Access Compliance Report

Public Rights-of-Way

Intersection ID: 10032114	Main Street: MORABLIN_DR	Cross Street: N/A	Location: W
ADA ID: D58A5159744C	Ramp Type: BlendTrans1	Initial Pass/Fail: Fail	Overall Compliance: No
			Severity Score: 33.75

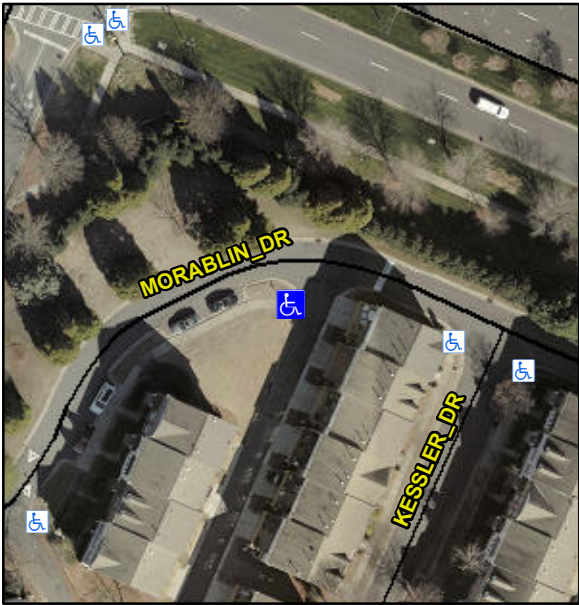
R304.5.1, R304.5.3

Remove & Replace Curb Ramp With Two New Directional Ramps or Equivalent.
